Figure 12: Modeled Existing Conditions (Without Project) velocity distribution (Ayres Associates)

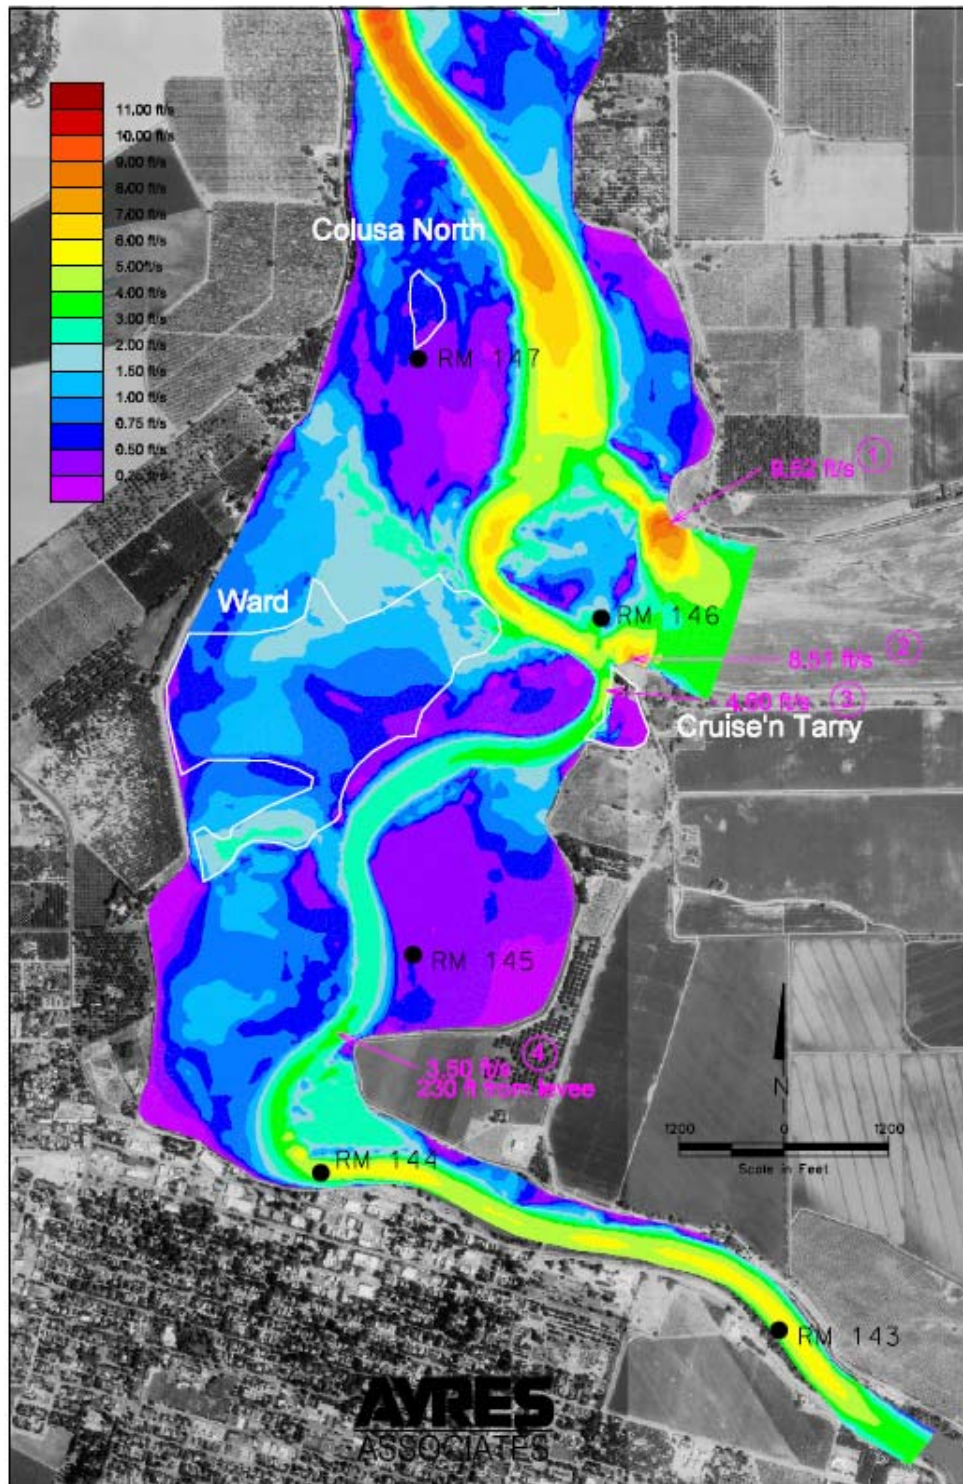
- Model results point to four areas that could be of concern under existing conditions (without project), depending on levee armoring at those sites. (See **Figure 12**).

- The model indicates that under existing conditions, when 160,000 cfs enters the Colusa Subreach, there are three locations adjacent to levees where velocities approaching or exceeding 5 ft/sec would occur. Locations 1 and 2 are located at the north and south edges of the entry to Colusa Bypass. Maximum modeled velocities there are between 8 and 10 ft/sec, in the range where armoring would likely be required for bank stability. Location 3 is at Cruise 'n Tarry. The maximum modeled velocity at Location 3 is 4.74 ft/sec, just below the 5 ft/sec threshold below which banks tend to be stable if well-vegetated.

- Under existing conditions, where the main channel curves toward the fourth location, along the East bank at river mile 144.6, velocities of up to 3.50 ft/sec occur in the center of the channel. The maximum velocity of 3.50 ft/sec occurs 230 ft out from the levee bank.

- Model results point to four areas that could be of concern under existing conditions (without project), depending on levee armoring at those sites.
- At these four areas of potential concern, DWR field-checked levee conditions. Site inspection revealed that all four sites have armoring sufficient to withstand the projected existing velocities:

**Figure 13: Net changes in velocity; Difference between modeled Existing Conditions (Without Project) and Restored Conditions (With Project) velocity distributions (Ayres Associates)**

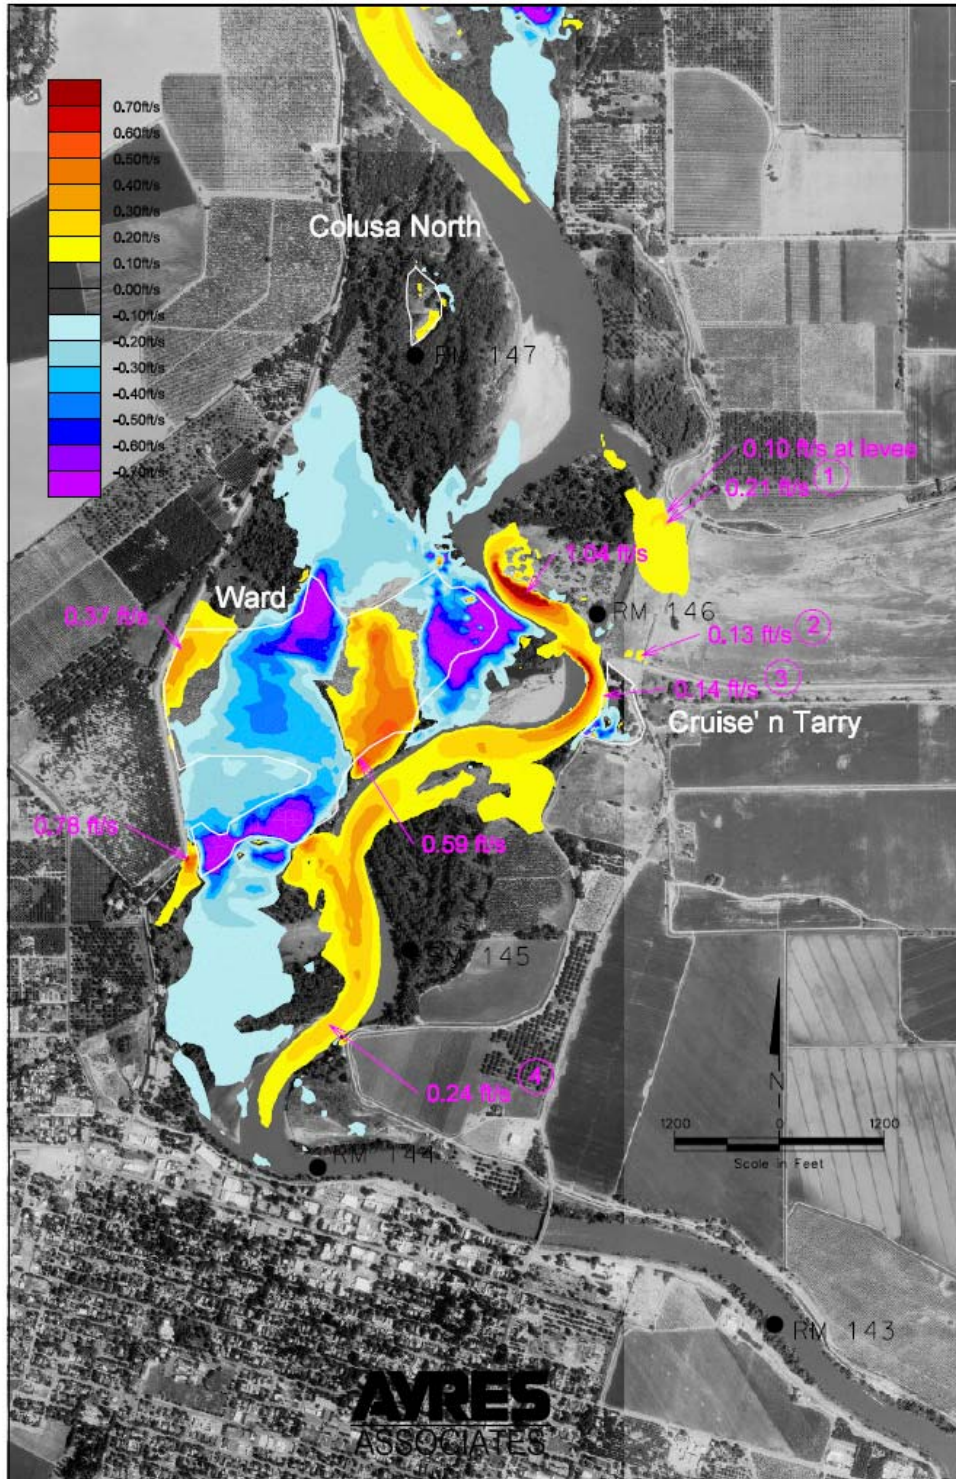
- Net changes in velocity modeled to occur if the project is implemented are shown in **Figure 13**. The difference between existing conditions and restored conditions (with project) modeled velocity distributions is sometimes positive, and sometimes negative. In other words, the graphic depicts show some increases in velocity (shown in warm colors) and some decreases in velocity (shown in cool colors).

- Some velocity increases shown in **Figure 13** occur where, given the original, existing condition velocities shown in **Figure 12**, they are not significant.

- Three of the areas of velocity increase shown in **Figure 13** occur where original, existing condition velocities are low. There are two areas along the western levee (note the 0.37 ft/sec and 0.78 ft/sec call outs in **Figure 13**). The third occurs in the “overbank flow corridor” of low hydraulic roughness vegetation (grass and savannah) that runs through the center of Ward Tract in the proposed restored condition.

- Velocity increases also are shown in **Figure 13** in the main channel for approximately two river miles adjacent to and downstream of Ward Tract. The maximum velocity increase is called out, at 1.04 ft/sec, across from the entrance to Colusa Bypass.

- Velocity increases at the four sites where there is potential for concern under existing conditions (without project), depending on levee armoring, are also called out in **Figure 13**:

- Location 1, along northern levee at entry of Colusa Bypass: 0.10 ft/sec increase (maximum velocity increase of 0.21 occurs at a distance from the levee in this general area)

- Location 2, along southern levee at entry of Colusa Bypass: 0.13 ft/sec increase
  - Location 3, Cruise 'n Tarry: 0.14 ft/sec increase
  - Location 4, main channel at river mile 144.6: 0.24 ft/sec increase

- Modeling results indicate that the restoration project would increase velocities by 0.1 to 0.14 ft/sec near levees at locations 1, 2, and 3, and 0.24 ft/sec at location 4. (See **Figure 13**). These are relatively small velocity increases. Just as all four locations are competent to withstand the projected existing conditions (without project) velocities under the modeled scenario, they are competent to withstand the increased velocities under restored conditions (with project).

- Acceleration across the overbank flow corridor (the area to be planted with grass and oak savannah) across Ward Tract is desirable, as it is a feature that limits the hydraulic effects of the project. Because the acceleration is focused in a low velocity area, no erosion is expected to develop in the overbank flow corridor.

- Acceleration within the main channel is also shown. The pattern of acceleration, coupled with the existing velocities along those bends, tends to suggest an incremental increase in erosion of sandbars that have formed may occur. This is especially true of the sandbar located opposite the entrance to Colusa Bypass. Reworking of this sandbar is seen as desirable from a flood management perspective. No appreciable change to the sand bar on the Ward Tract would be expected based on the model results.

- Because the areas of greatest reduction in velocity are concentrated within the Ward Tract, (see **Figure 13**), new tendency toward deposition is also concentrated within the Ward Tract property. Recall that the Ward Tract property is somewhat larger than the Ward restoration outlined in the modeling graphics (see **Figure 2**).

Figure 14: Restored Conditions (With Project) modeled velocity distribution (Ayres Associates)

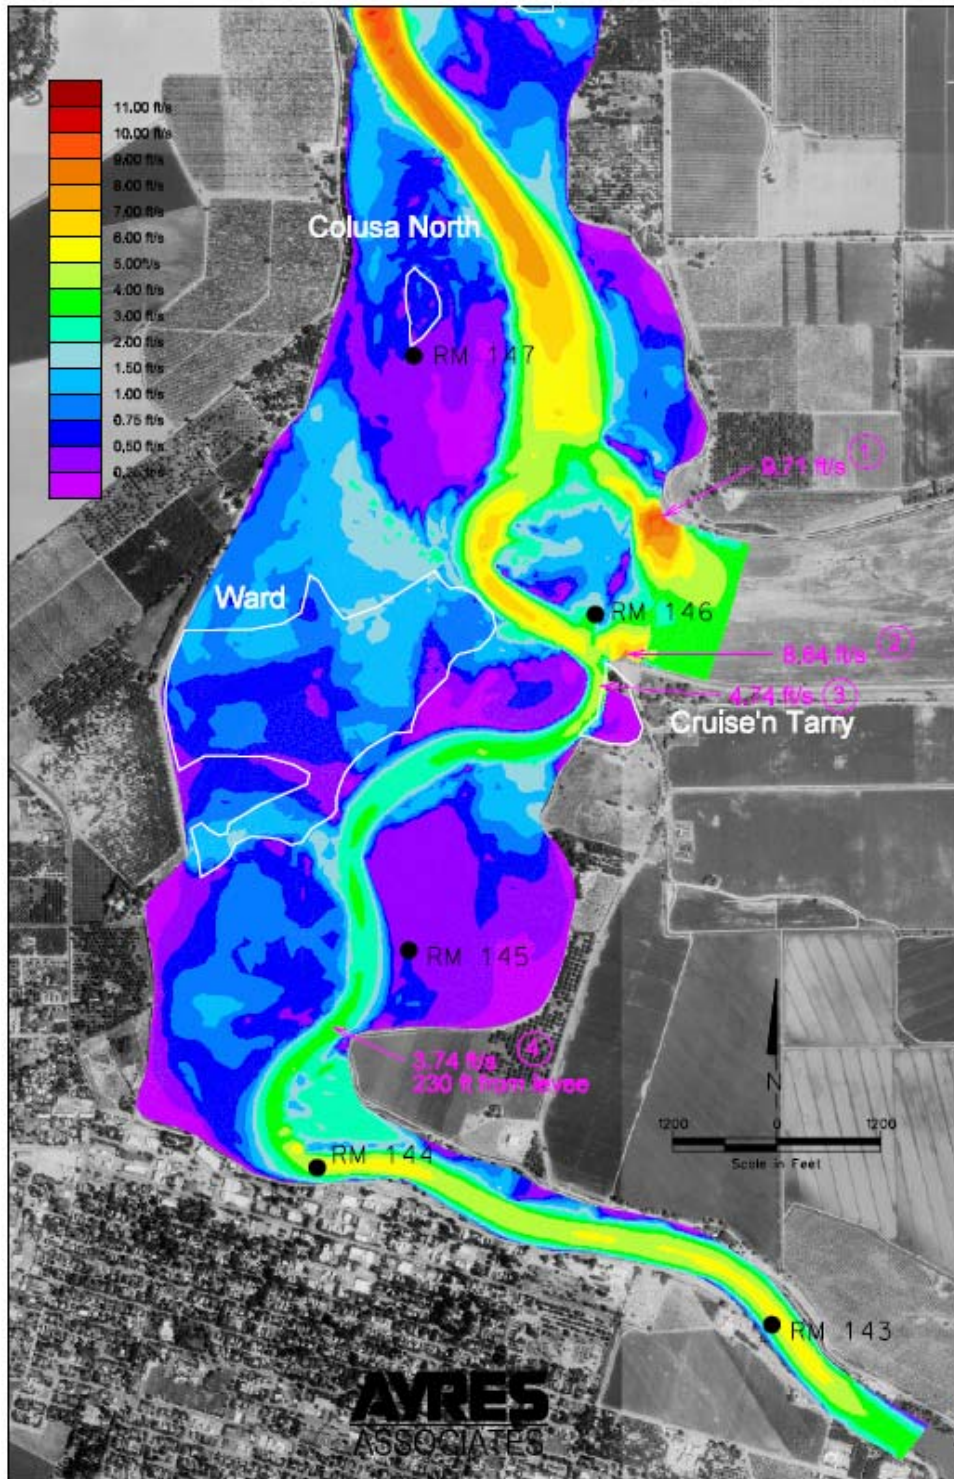
- The areas of greatest reduction in velocity are concentrated within the Ward Tract. (See **Figure 13**). The resultant velocities under restored conditions (with project) are shown in **Figure 14**. In side by side comparison of **Figure 14** with **Figure 12**, what stands out most is the increase in in-channel velocities.

- Resultant maximum velocities maxima at the four sites where there is existing potential for concern are called out in **Figure 14**:
  - Location 1, along northern levee at entry of Colusa Bypass: 9.71 ft/sec

- Location 2, along southern levee at entry of Colusa Bypass: 8.64 ft/sec
  - Location 3, Cruise 'n Tarry: 4.74 ft/sec
  - Location 4, main channel near levee at river mile 144.6: 3.74 ft/sec 230 ft from levee.
